RE: Big Blue Site Permit Major Deviations

#### **1. Turbine Noise Study Model Changed**

This is a screenshot from the Site Permit showing the Repower MM92 turbine modeled for noise.

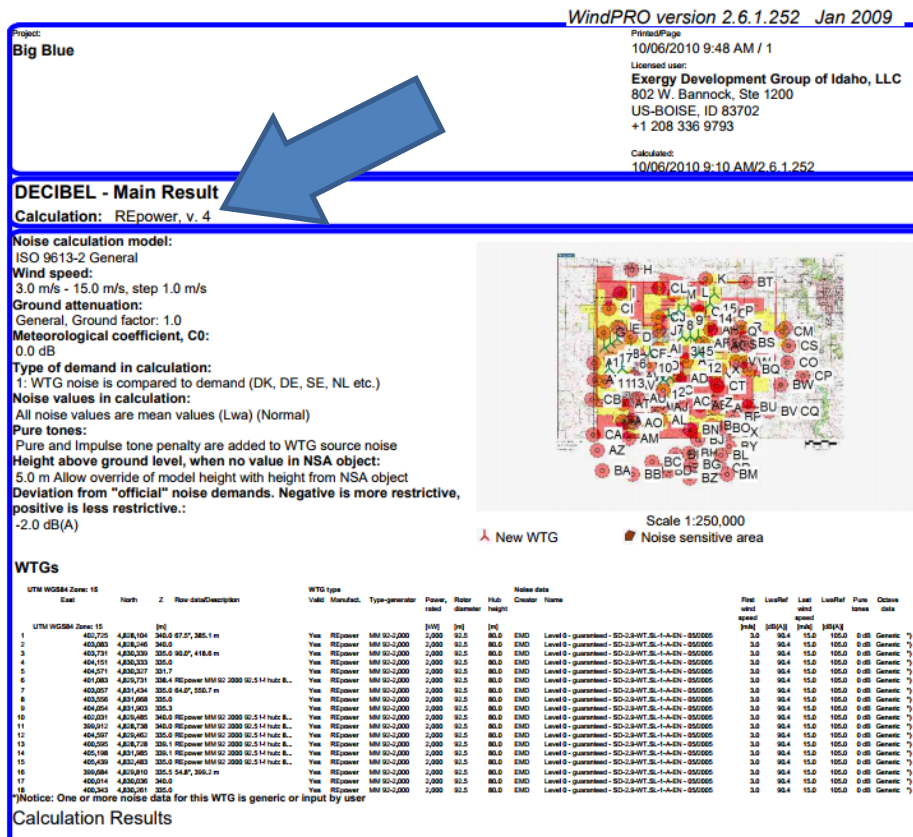
Initially in December of 2010, when Big Blue applied for a 36 MW windfarm they were unsure which turbine they would erect so they studied the GE SLE 1.5 MW and the REpower MM92 2 MW machines. In May of 2011 they changed the layout to the Gamesa G97 2MW machine however they never modeled the noise impacts of changing from the MM92 to the G97. (Docket ID #201114-62080-01) However all of the technical details in section 5 of the application stays the same. In other words, they took the noise and shadow flicker from the MM92 study, and applied it to the G97.

Noise Emission Data (LwaRef) is the turbine manufacturer's noise analysis. The Big Blue project was modeled using the LwaRef of the MM92 turbine (Docket ID #201012-57190-06) which is 1.4 dba quieter than the G97 turbine.

REpower MM92 LwaRef=105 dba (Docket ID #201012-57186-10 page 22 Sec 8.3 Noise attenuation Wind Pro calculations of the MM92)

Gamesa G97 LwaRef = 106.4 dba (The Big Blue G97 turbines were never modeled for this project, so I had to use Google to find a similar project using G97's to find the LwaRef. project Hoge-Vag-20140512-VB 2014)

Why was this project able to change the turbine, when the noise emitted is higher than what was allowed under the permit? Would the setback requirement have changed? **Not all turbines are created equal**. The fact is, Big Blue never knew how noisy this turbine and blade configuration would be because they never modeled the project using the machines they built.
